Beasley Subdivision

S DIVISION SUMMARY FORM

CITY OF GRAND JUNCTION

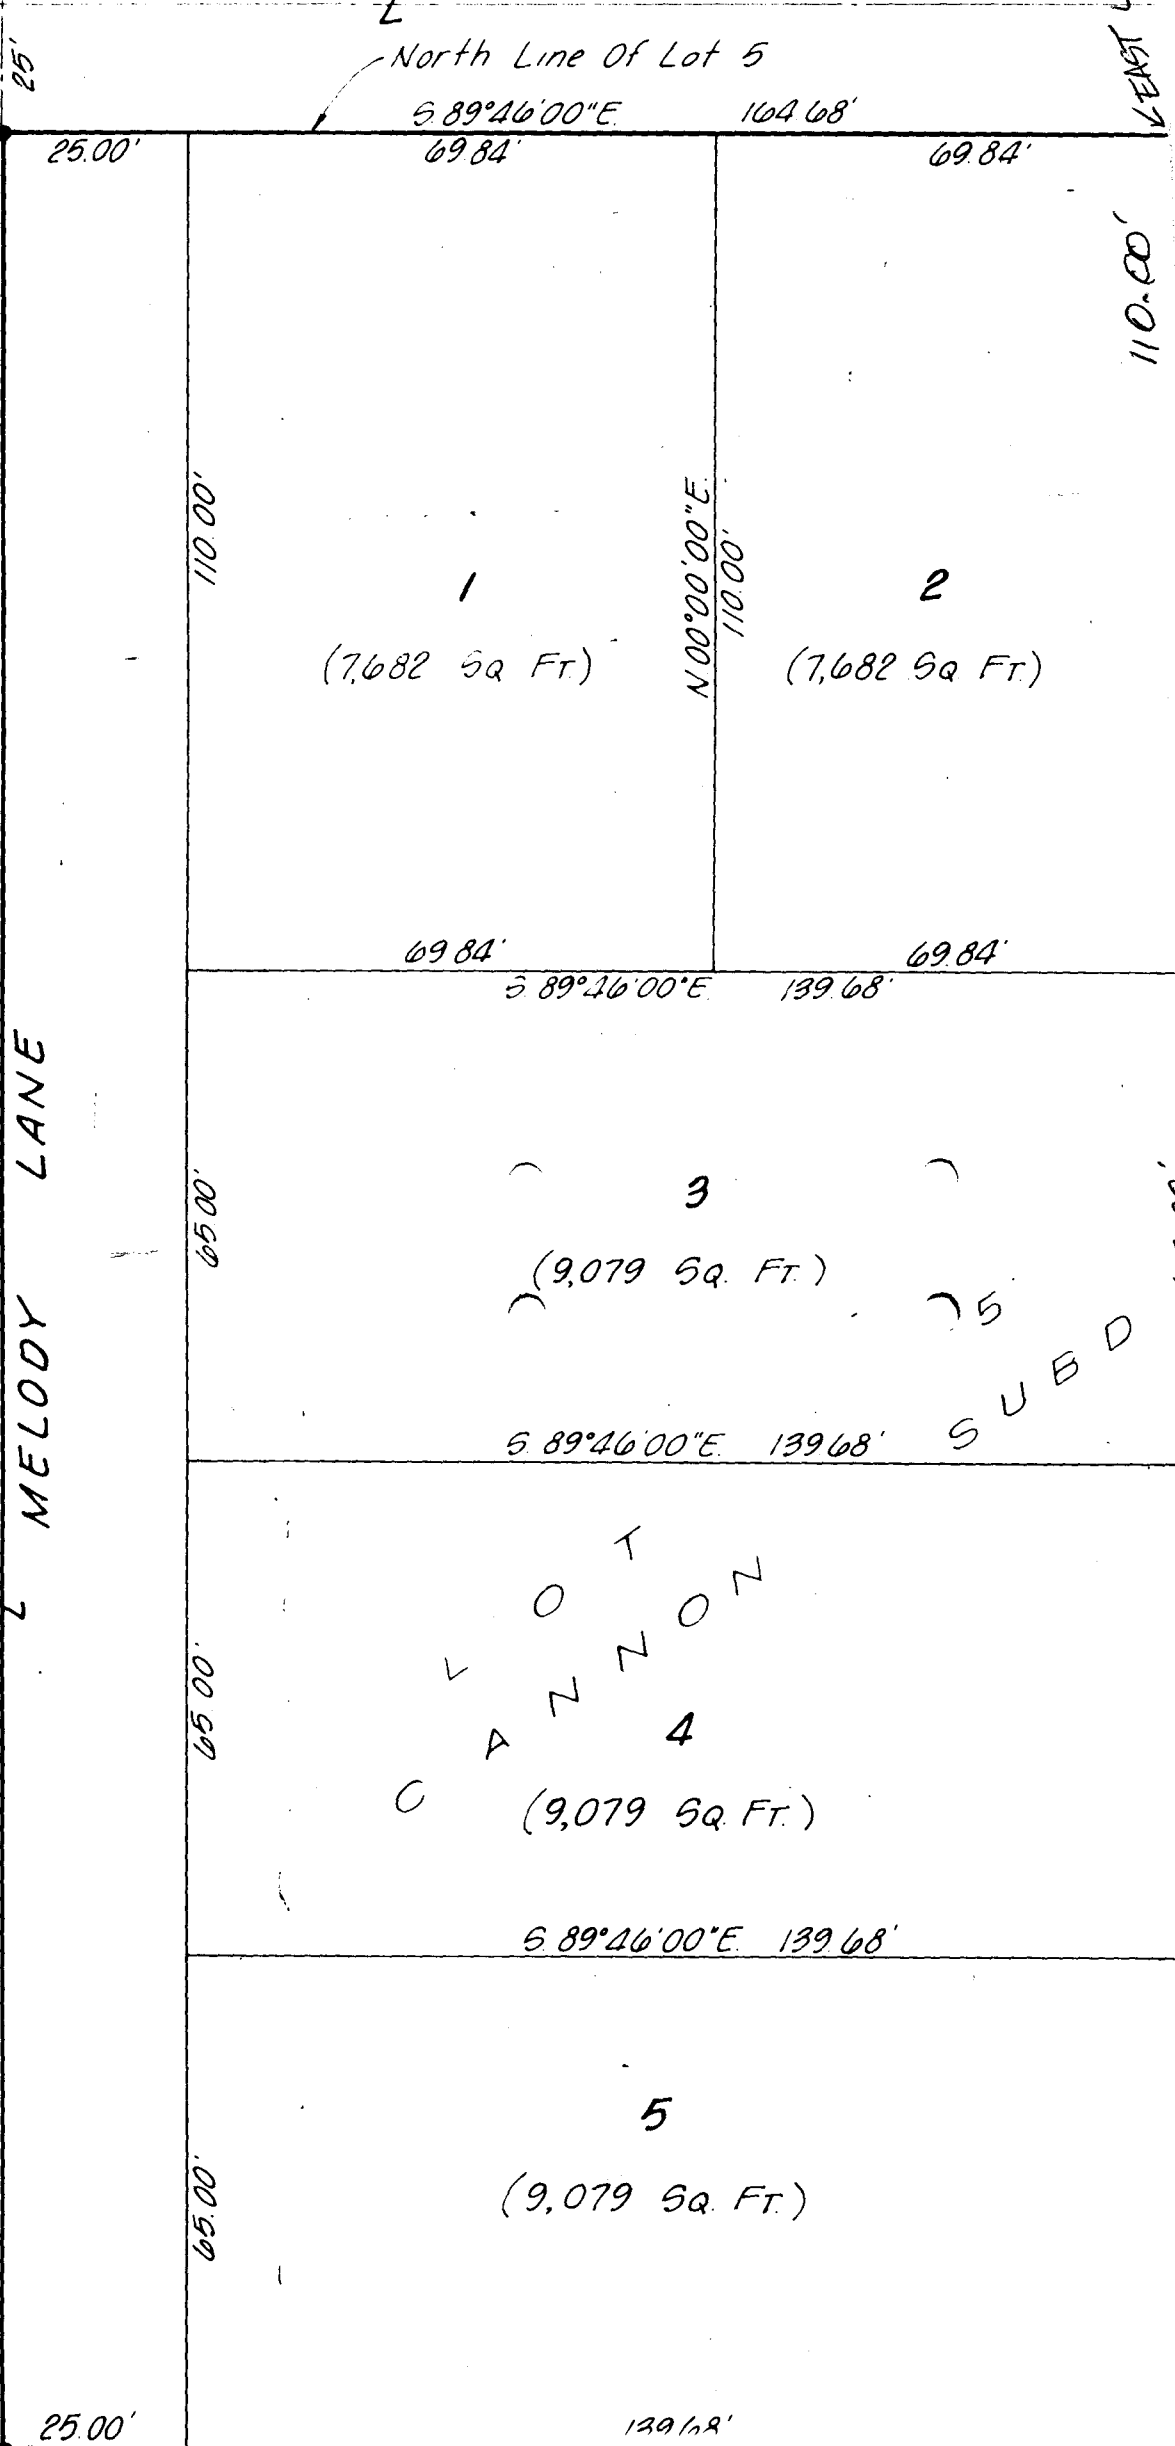
Have the surveyors check the existing house on Beasley Sub as to its relation to East lot line. If it falls within easement contact Telephone Co. to narrow easement. Have all easements placed on the mylar. We will need a power of attorney to place lots in an improvement district for street constr. Talk to Beasley. It would seem to be best to put in Curb - Gutter - Sidewalk before CO's and use the imp. dist. for paving. See if he will agree to this
